PROJECT DATA
6 STORIES
259 UNITS

FLOOR PLANS - LEVEL -1

Enclave - Bloomington Drury

1 SD Site Plan
1" = 100'-0"

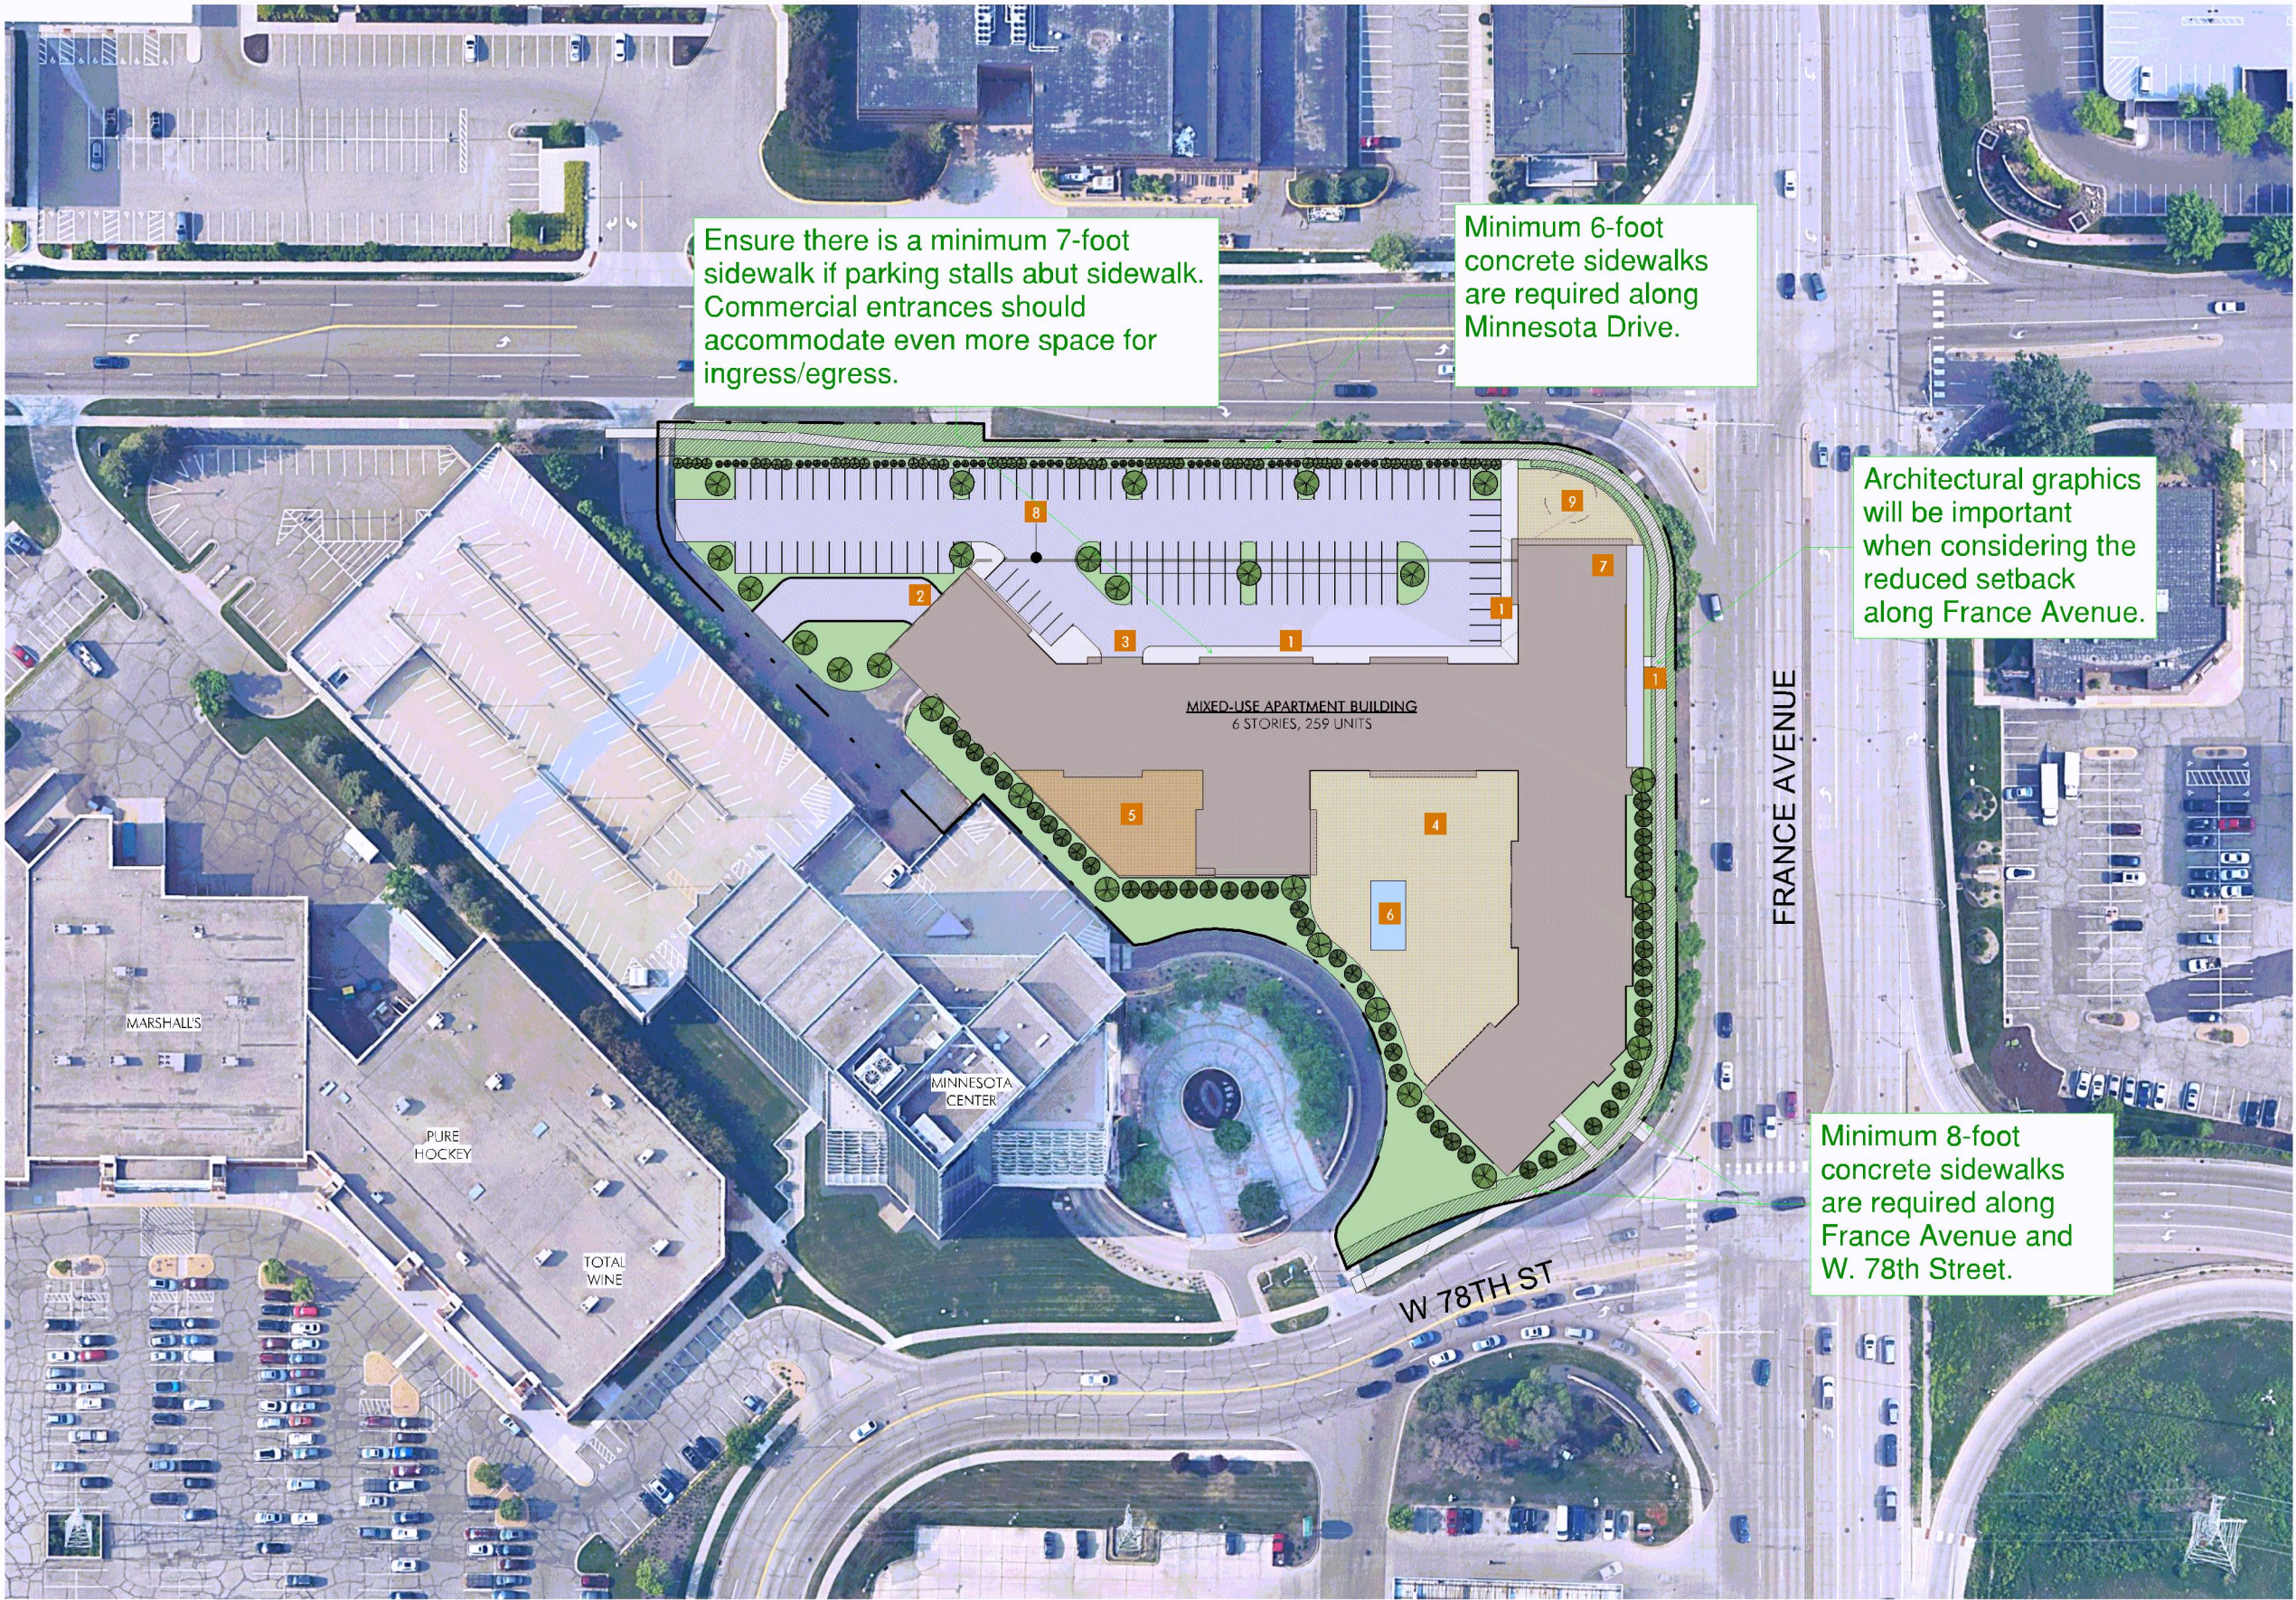
All emergency vehicle access lanes including all areas of the parking structure (top and lower levels) shall support a minimum 40 tons.

Standpipes requirement in all stairwells and hose valves shall be located at the floor landing

1 Level -1
1" = 50'-0"

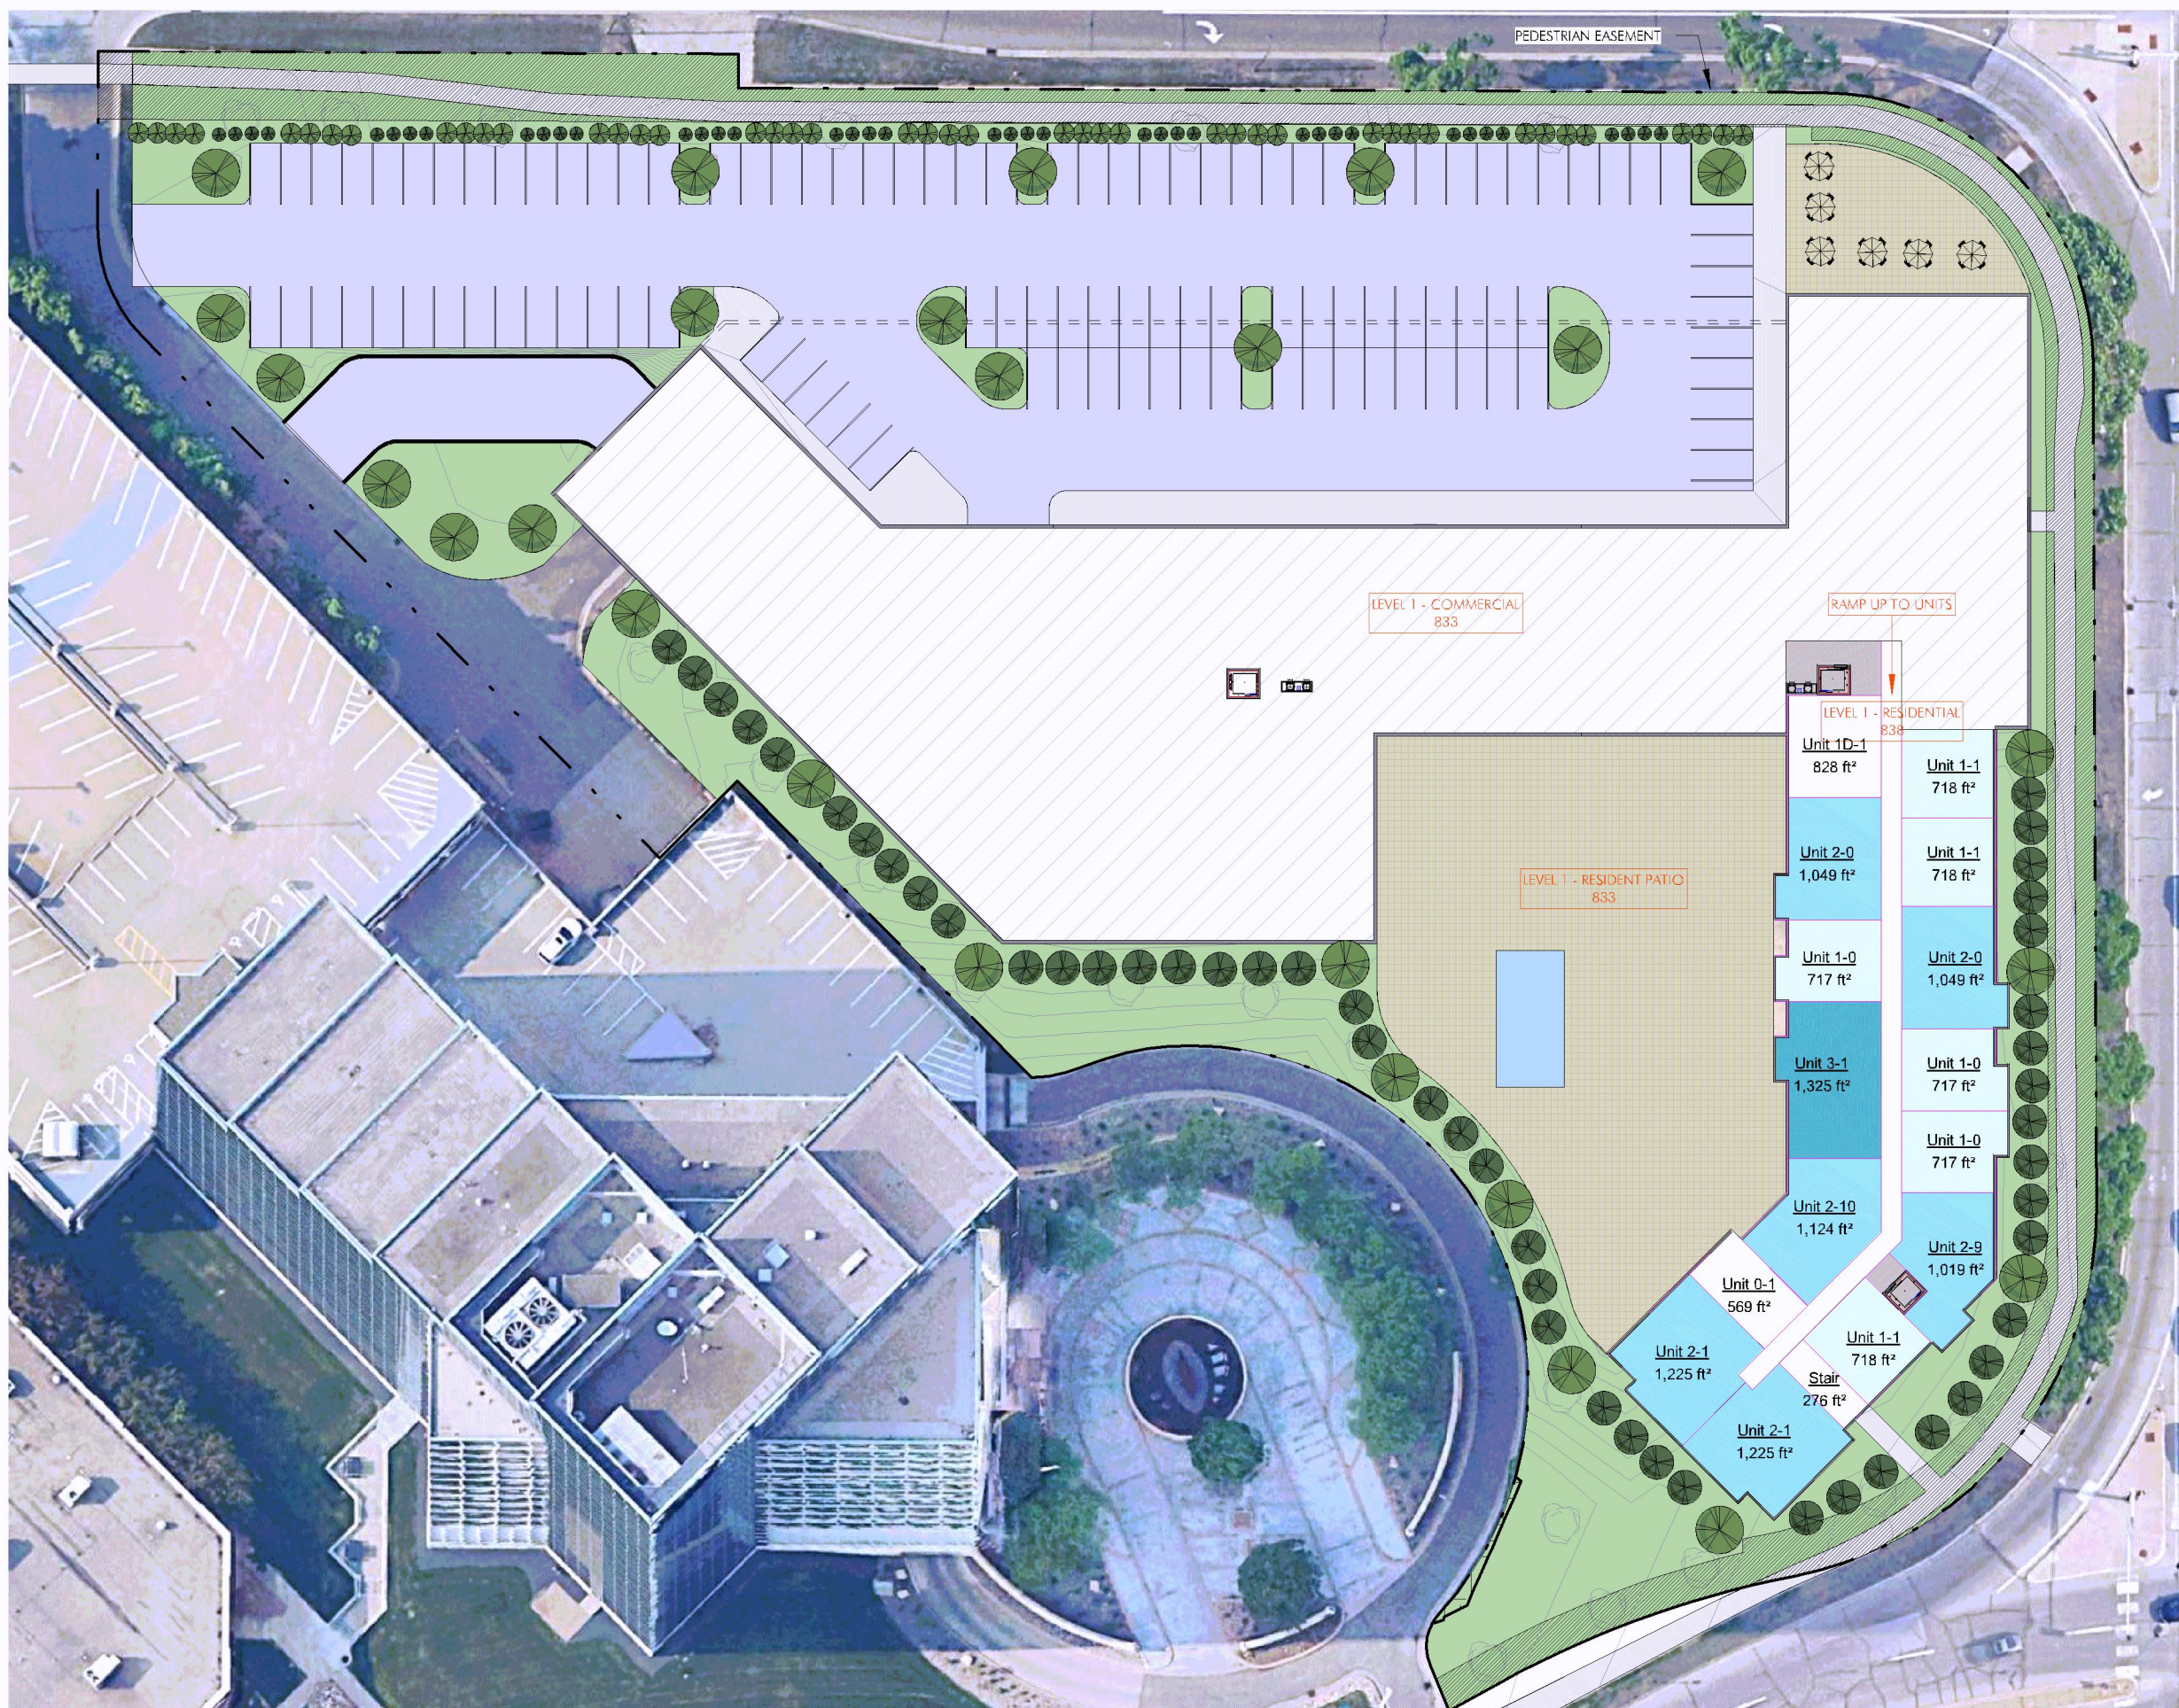
Hose valves shall be provided throughout the lower level of the parking ramp.

Ensure there is at least 2 feet between the edge of the sidewalk and any obstructions.
